REMARKS

I. OBJECTIONS TO THE DRAWINGS

IN THE DRAWINGS

FIG. 4B

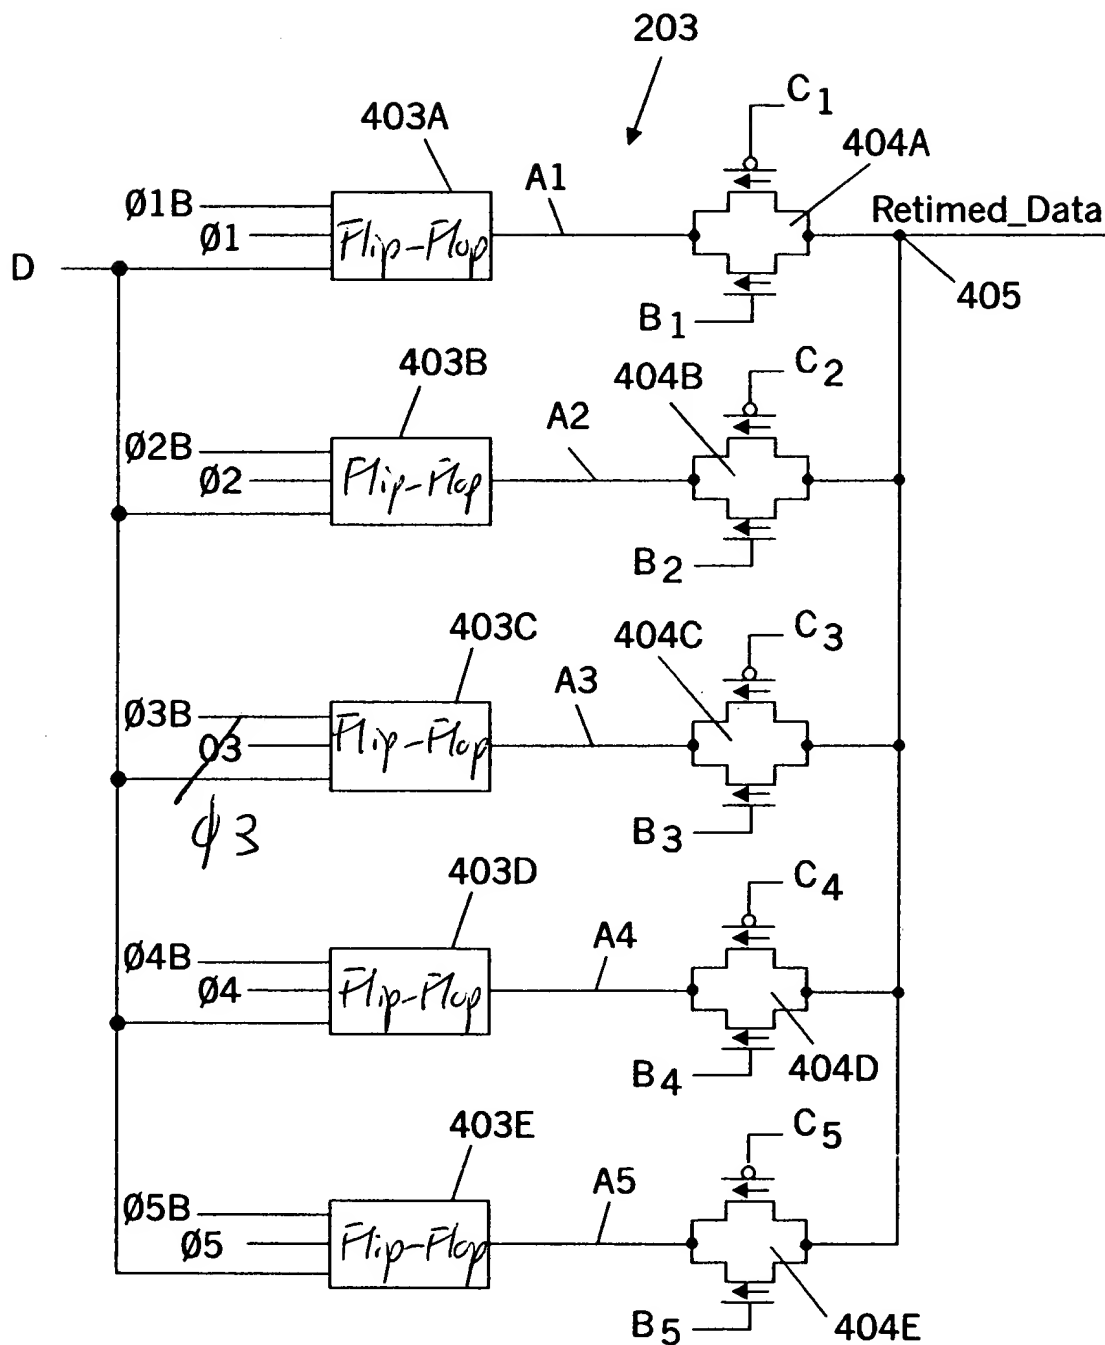
The Examiner has objected to Figure 4B because the reference sign "03" should be "Ø3" as well as missing a label for elements 403A-E. The Examiner has further objected to Figure 4A since elements 401A-E do not contain a label. Applicant has amended Figure 4B to include the appropriate reference sign "Ø3" as well as added the label of "Flip-Flop" to elements 403A-E, as indicated above. Applicant, however, does not believe that a label to elements 401A-E is warranted as a person of ordinary skill in the art understands that the symbols of elements 401A-E are NAND gates.

Applicant has replaced the incorrect label "03" with the correct label "Ø3" in Figure 4B. Applicant has further added the label of "Flip-Flop" to elements 403A-E in Figure 4B. Applicant has attached an annotated sheet of Figure 4B indicating the replacement of the label "03" with the label "Ø3" as well as the addition of the label "Flip-Flop" to elements 403A-E. Applicant has further attached a replacement sheet for Figure 4B incorporating the changes mentioned above.
